STATE OF MAINE
DEPARTMENT OF TRANSPORTATION
16 STATE HOUSE STATION
AUGUSTA, MAINE 04333-0016

October 1, 2020
Subject: Pleasant River Bridge
Replacement
State WIN: 022627.01
Location: **Milo**
Amendment No. 1

NOSE ARMOR DETAIL

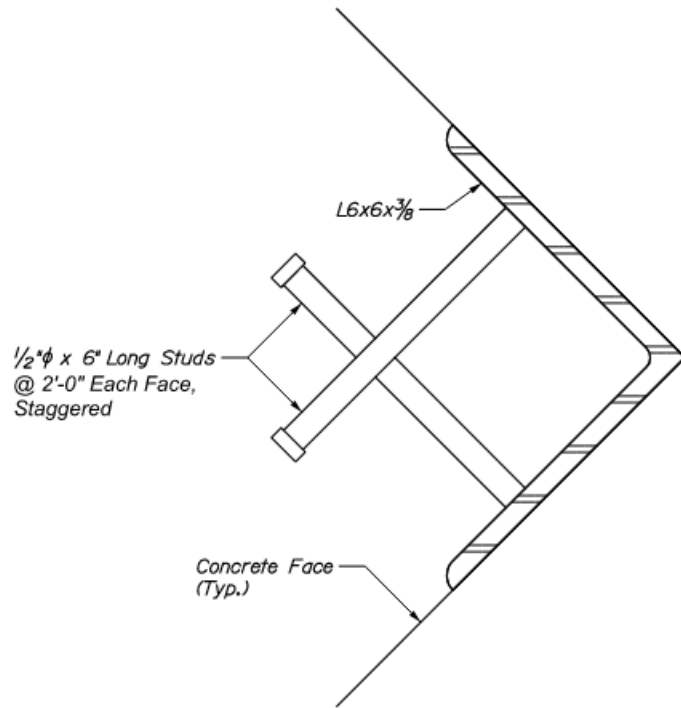
ADD the attached NOSE ARMOR DETAIL to SHEET NUMBER 73 OF 91, PIER NOTES.

Question: The pier notes specify a Nose Armor, including anchor studs. Please provide a detail on the Nose Armor to be provided.

Response: The attached detail shall be added to Sheet 73 of 91 of the plans.
